# UNITED STATES PATENT AND TRADEMARK OFFICE

10/748,443

<b>Office Action Summary</b>	<b>Application No.</b> 10/748,443	<b>Applicant(s)</b> CHRISTIE ET AL.	
	<b>Examiner</b> CHRISTINA NEGRELLI	<b>Art Unit</b> 3733

## DETAILED ACTION

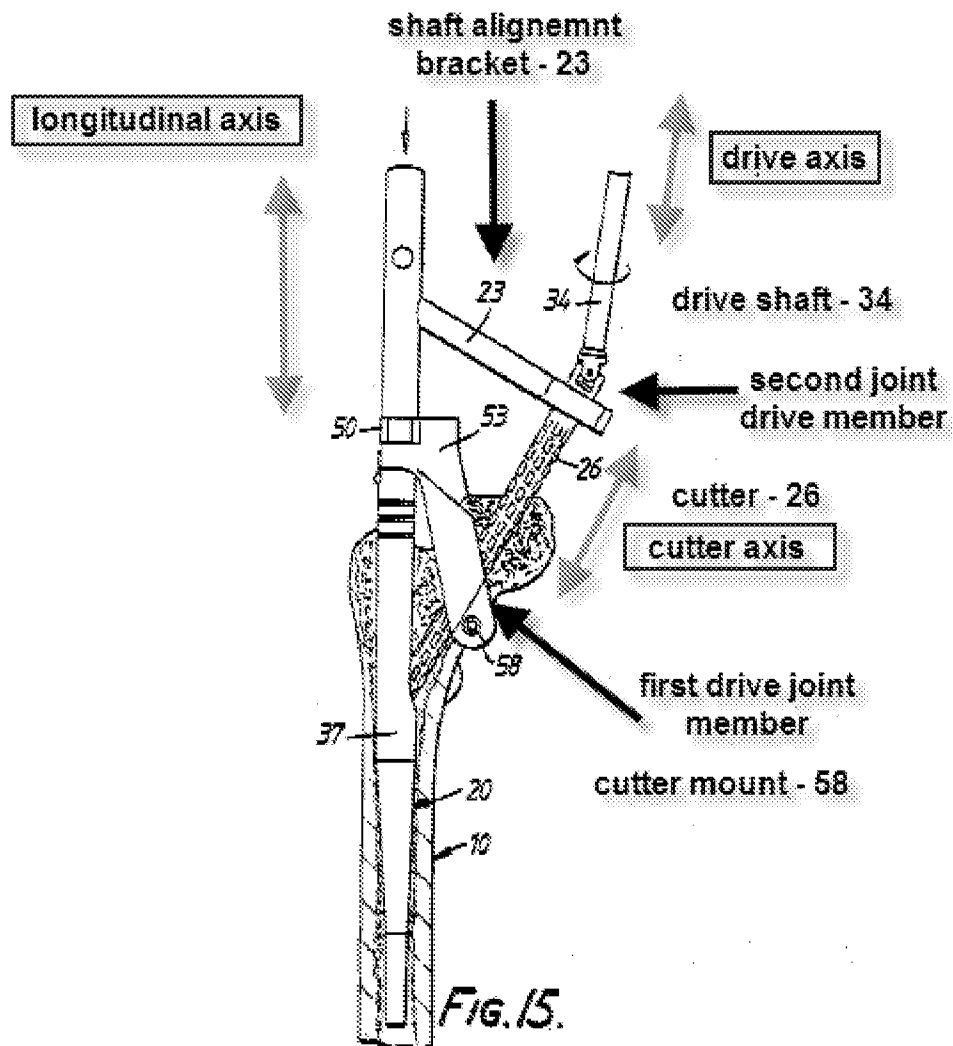
As to claims 24, 32 and 39, the applicant asserts that Freeman fails to disclose two separate mounts which support a cutter and a drive shaft coupled to the cutter. The applicant asserts that Freeman discloses only a single mount, and fails to disclose a structure that supports the drive shaft. The examiner respectfully disagrees.

Freeman discloses two distinct mounts, a cutter mount (ref.58) and a shaft alignment bracket (ref.23) as seen in Fig.15. The cutter mount is configured to support the cutter (26). The shaft alignment bracket supports the drive shaft (34). There are two distinct mounts as can be seen in Fig.15. The drive shaft includes "a distal end with a second drive joint member," noted in Fig.15. The second drive joint member is coupled with the first drive joint member to rotate (see Fig.5) the cutter about the cutter axis (col.5, ll.7-20). For these reasons, the rejection of claims 24, 32, and 39 still stand.
